SUBJECT: **NEW VEHICLE DEMONSTRATION / DELIVERY HOLD - Compliance Recall 21C25 – Supplement #1**
 Certain 2019-2021 Model Year Ranger Super-Cab Vehicles
 Front Passenger Outboard Seatbelt Retractor Webbing Incorrectly Routed

New! REASON FOR THIS SUPPLEMENT

- **Service Action:** *The direction to replace seatbelts that fail inspection has been provided.*
- **Owner Letters and Owner Notification Mailing Schedule:** *Parts available owner letters and mailing dates are now available.*
- **Administrative Information:** *Rental information has been updated.*
- **Labor Allowances and Parts Ordering Information:** *Labor Operation Codes and Parts Ordering Information has been updated.*
- **Technical Information:** *The Technical information has been updated and now includes examples of acceptable and unacceptable photo evidence of a miss routed seatbelt.*

FIGURE 2

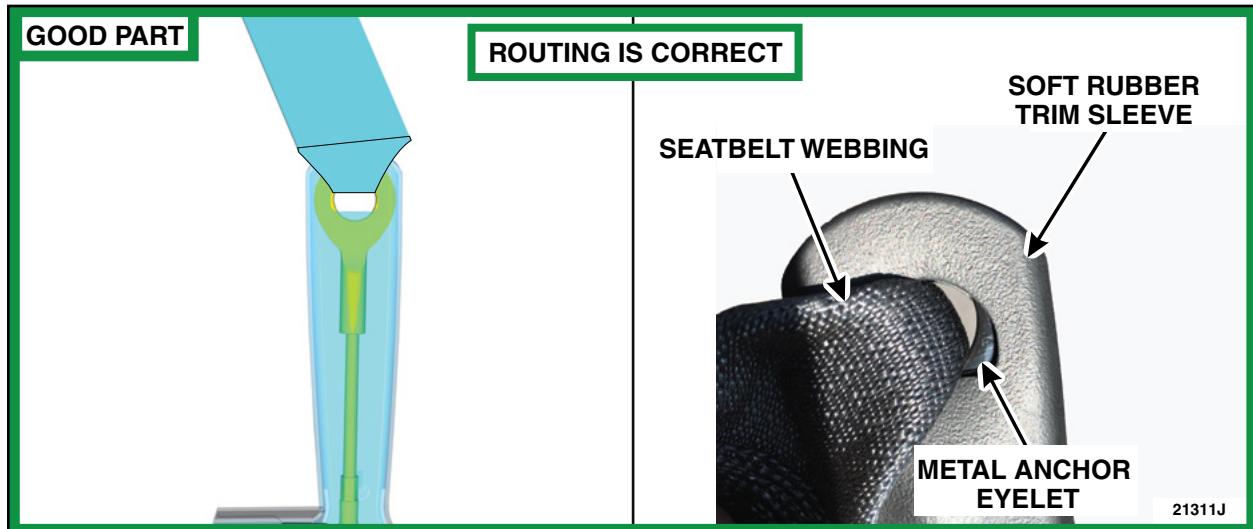
3. Visually inspect that the driver side front seatbelt webbing is routed through the soft rubber trim sleeve **AND** through the metal anchor eyelet. See Figures 2 and 3.

-Is the seatbelt webbing routed through the soft rubber trim sleeve **AND** through the metal anchor eyelet?

Yes – First inspection (visual only) passes. Proceed to Step 4.

No – First inspection (visual only) does not pass. Install a *new* Front Seatbelt Retractor and Pretensioner assembly. Please follow Workshop Manual (WSM) procedures in Section 501-20A then proceed to Step 6.

FIGURE 3

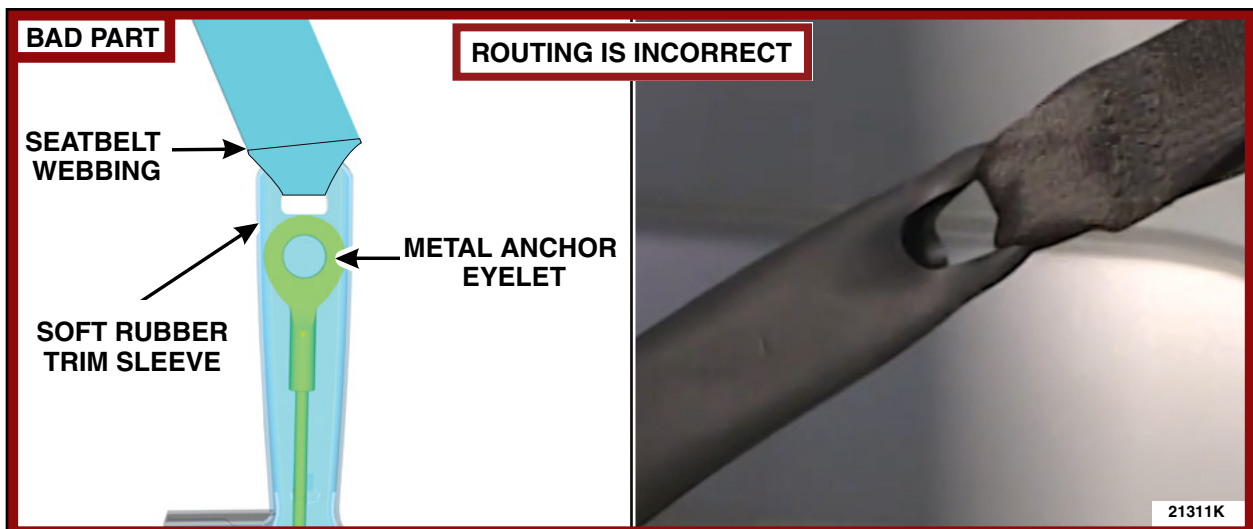
4. Grab the seatbelt webbing just above where the seatbelt webbing loops through the soft rubber trim sleeve and attempt to bend the rubber trim sleeve towards itself as shown in Figure 4 (Bad Part). The seatbelt rubber trim sleeve should **NOT** bend or fold over.

No – Second inspection (bend test) passes. Proceed to Step 5.

Yes – Second Inspection (bend test) does not pass. Install a *new* Front Seatbelt Retractor and Pretensioner assembly. Please follow WSM procedures in Section 501-20A then proceed to Step 6.

FIGURE 5

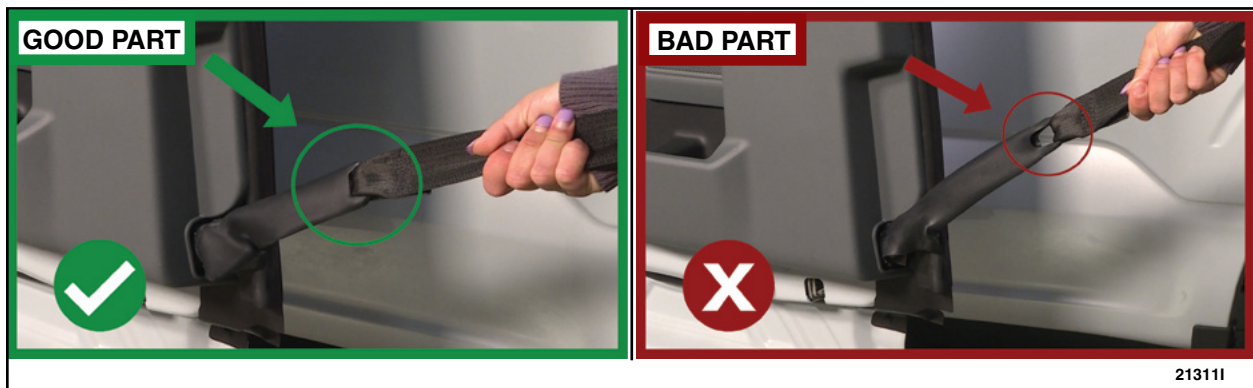
5. Make sure you are standing in a comfortable, well-balanced position and firmly grab the seatbelt strap just above the soft rubber trim sleeve with two hands. Strongly pull the seatbelt towards you while looking at the area where the seatbelt webbing loops through the sleeve. See Figure 5.

-Did the rubber trim sleeve opening stretch where the seatbelt webbing loops through the sleeve?

No – Third inspection (pull test) passes. Seatbelt replacement is not required. Proceed to Step 6.

Yes – Third Inspection (pull test) does not pass. Install a new Front Seatbelt Retractor and Pretensioner assembly. Please follow WSM procedures in Section 501-20A then proceed to Step 6.
